MEMORANDUM

Subject: S11-12 Canal Consolidation, Diversion Berm Underwater Inspection, April 13, 2007, Upper Salmon River Water Optimization Project, Idaho

A special examination of the S11-12 Diversion Berm on the Salmon River was conducted by PN Regional Underwater Inspection Team members on April 13, 2007.

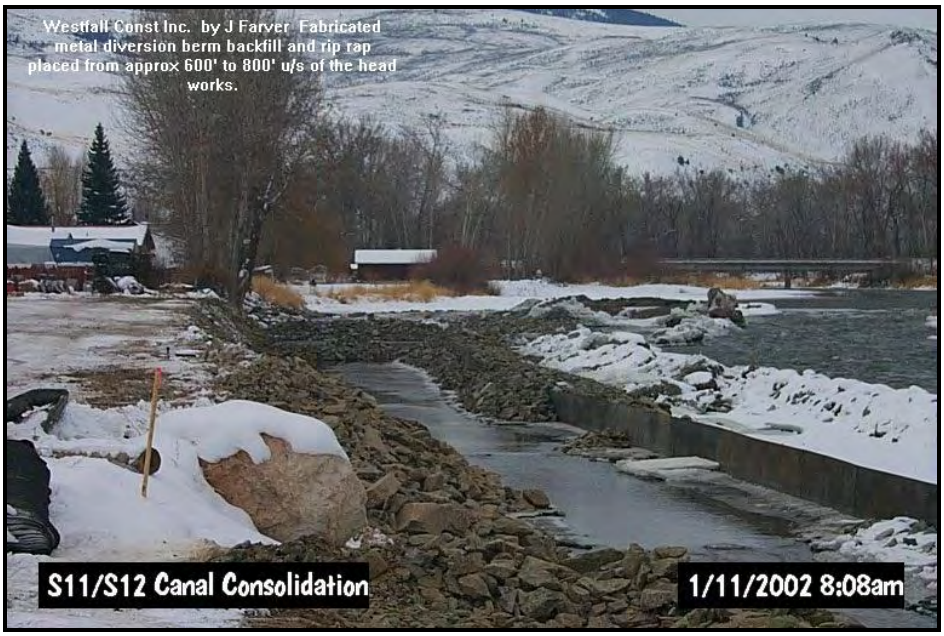
Photograph No. 1. View looking upstream during construction of the with S11-12 diversion berm. Note the exposed "T-plate" and the cobble backfill around the "T-plate." Salmon River is in far right of photograph. **PN Regional Underwater Inspection Team – S11-12 Diversion Berm , Upper Salmon River Water Optimization Project, Idaho.**

Photograph No. 2. View looking upstream after construction was completed. S11-12 irrigation canal and Salmon River are divided by the diversion berm, headgates, and Salmon River. **PN Regional Underwater Inspection Team – S11-12 Diversion Berm, Upper Salmon River Water Optimization Project, Idaho.**

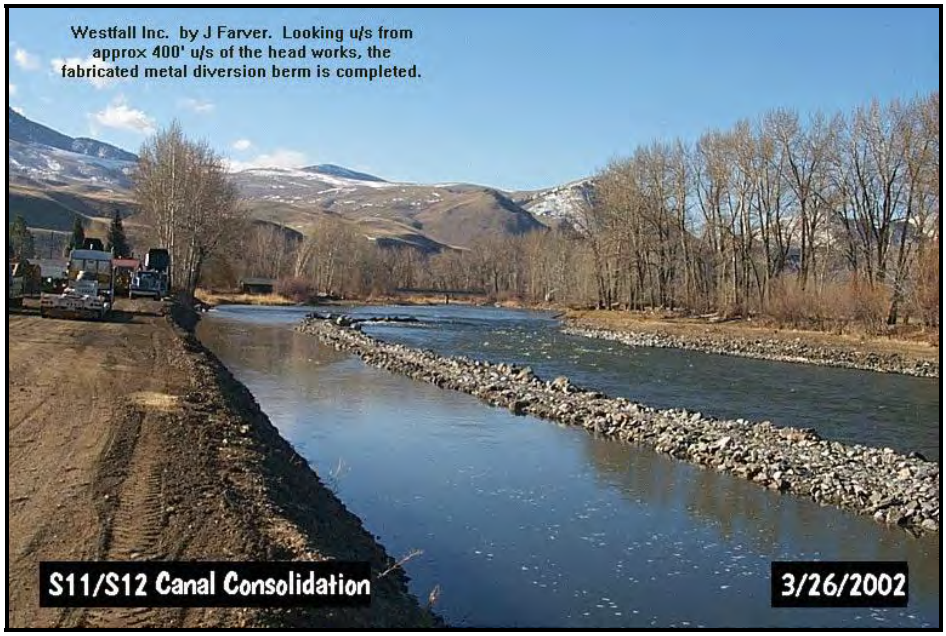
Photograph No. 4. View looking at boulder wing wall and beginning of diversion berm. Note backfill material missing downstream from wing wall. T-plate exposure was approximately 4 feet in this area. **PN Regional Underwater Inspection Team – S11-12 Diversion Berm, Upper Salmon River Water Optimization Project, Idaho.**

Photograph No. 5. View of divers measuring "T-plate" exposure at end of boulder wing wall. Material missing was approximately 4 feet, leaving approximately 12 inches of embedment. **PN Regional Underwater Inspection Team – S11-12 Diversion Berm, Upper Salmon River Water Optimization Project, Idaho.**

Photograph No. 6. View of diver measuring "T-plate" exposure at approximate Station 4+00 (midway of diversion berm). Note amount of material present. Exposure of "T-plate" was approximately 6 inches at this location. **PN Regional Underwater Inspection Team – S11-12 Diversion Berm, Upper Salmon River Water Optimization Project, Idaho.**

FIGURE 1

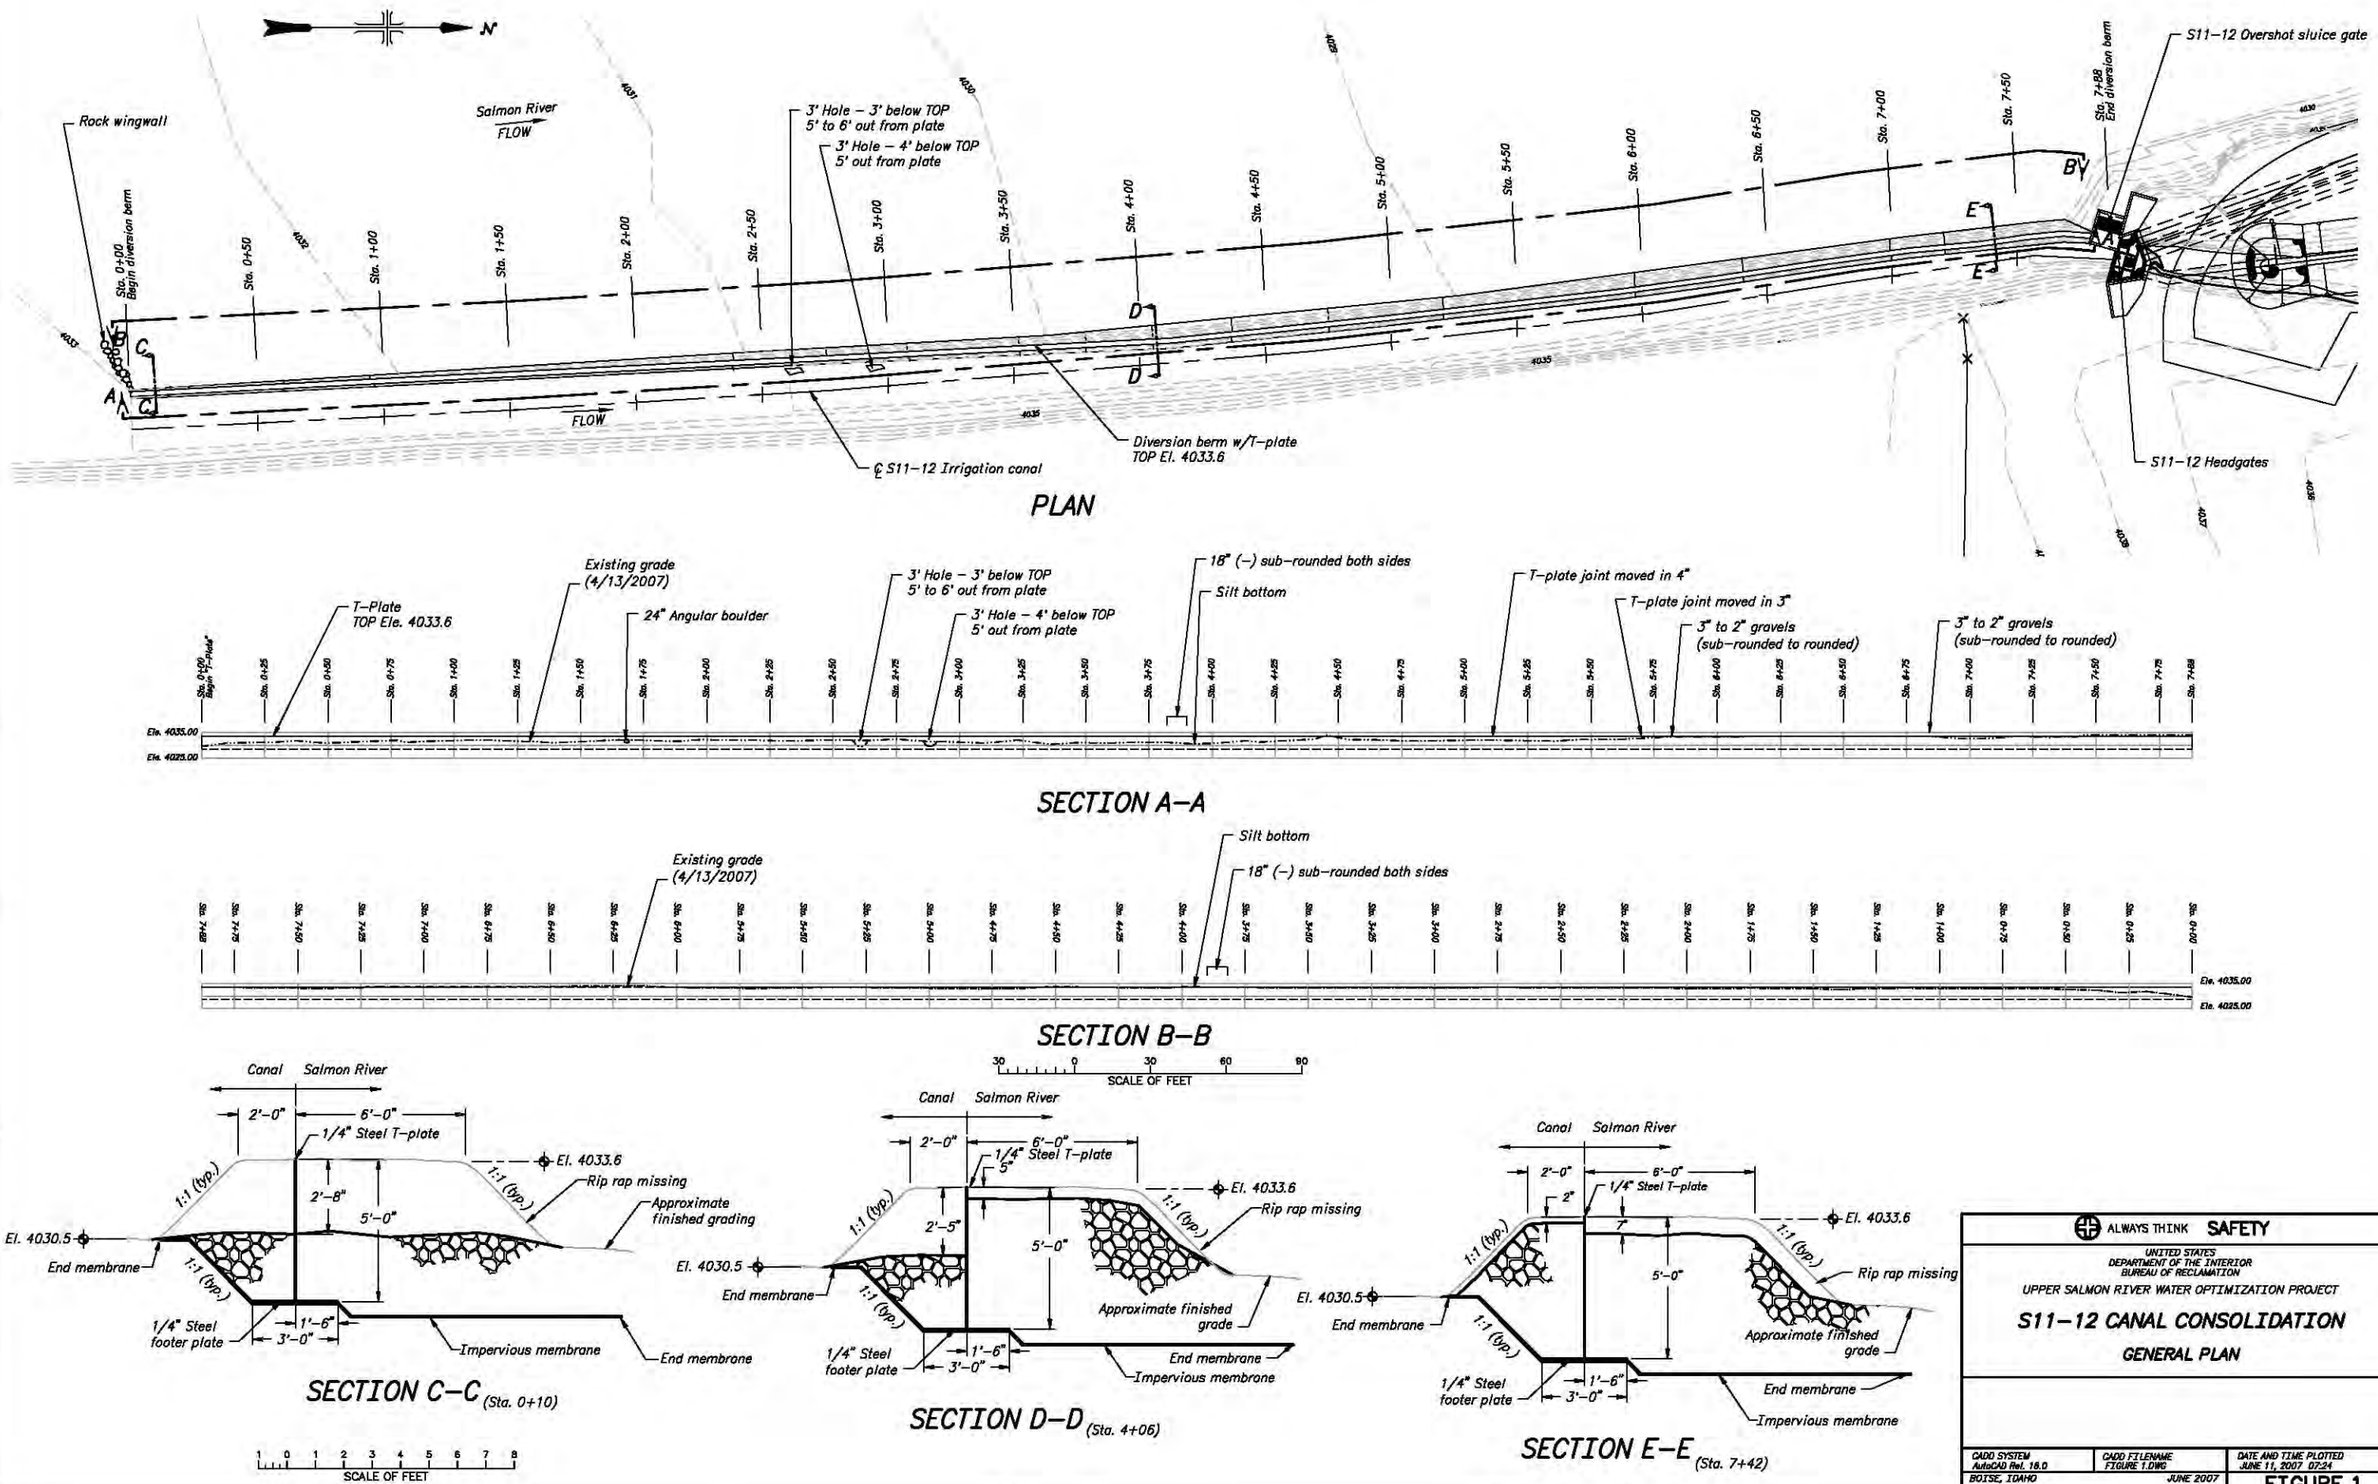
The upstream end of the diversion berm was accessed by divers swimming across the diversion canal and wading upstream to the beginning of the diversion berm (Station 0+00). Divers then waded downstream along the "T-plate" stopping every several feet to measure the distance from the top of the "T-plate" down to the top of existing riprap. Refer to Photograph Nos. 4 through 6, attached. The stationing and "T-plate" exposure of both inside (canal side) and outside (Salmon River side) were recorded from the bank by a third diver. The data is documented on Figure 1.

During the inspection neither undercutting nor tilting of the T-plate was noted and maximum amount of exposure of the 5-foot high T-plate was approximately 4 feet leaving approximately 1-foot of the T-plate and footer still buried. This exposure was noted at the first 10 feet starting at Station 0+00. All placed angular cobbles and boulders were well bedded with no undermining of the T-plate footer. Exposure of the T-plate varied from 4 to 0 feet with the furthest T-plate length (Stations 7+44 to 7+88) being buried (0 feet exposure of T-plate). Refer to Figure 1.

On the canal side of the diversion berm, approximately 260 cubic yards (yd^3) of material were placed to the top of the T-plate (elevation 4033.6). From depth of exposure of the T-plate, the amount of material that had been removed was approximately 84 yd^3 or approximately 32 percent of the original material. This material appeared to have been lifted up and over the T-plate and deposited on the river side or had been pushed downstream along the canal bank towards the headgates.

On the river side of the diversion berm, approximately 560 yd^3 of material were placed to the top of the T-plate (elevation 4033.6). From depth of exposure of the T-plate, the amount of material that had been removed was approximately 73 yd^3 or approximately 13 percent of the original material. This material was transported downstream by high flows of the river.

FIGURE 2

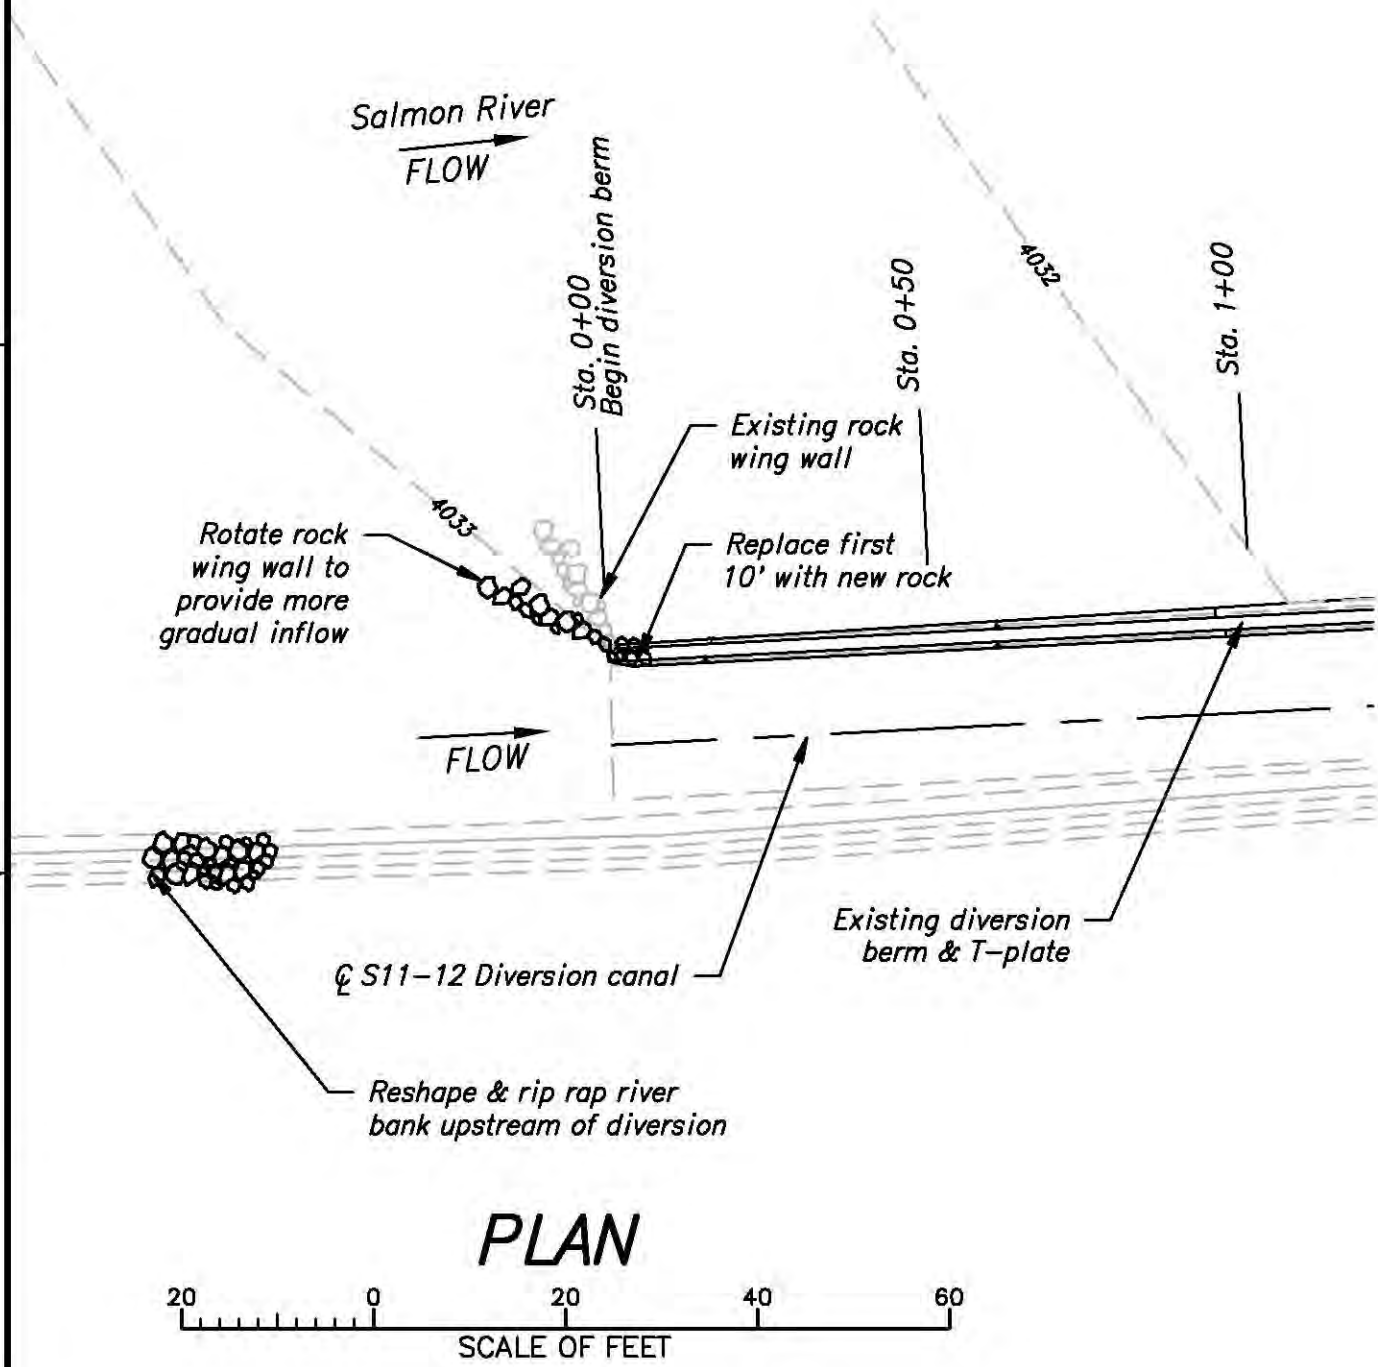
The T-plate and berm appeared to be stable with no undermining or tilting of the T-plate. The remaining rock was well bedded and appeared to be keyed in to prevent further moving. It was noted that the rock wing wall at the beginning of the diversion berm has a very sharp angle to river flows that is producing turbulent flow at the beginning of the berm. This is contributing to the removal of material from the first 10 feet of berm. It is recommended that this rock wing wall be moved further upstream and swung in toward the right bank to provide for a more gradual flow regime into the diversion canal. At the same time, additional angular rock (18- to 24-inch) could be placed on both canal and river sides for the first 10 feet of the T-plate to replace the missing rock fill that has been washed away. Refer to Figure 2, *S11-12 Canal Consolidation, Rock Wing Wall.*

Also, just upstream of the diversion berm on river bank right, the existing bank should be resloped and 18- to 24-inch angular riprap placed to help reduce sloughing in of the bank and to prevent additional bedloading from entering the diversion canal. Refer to Figure 2.
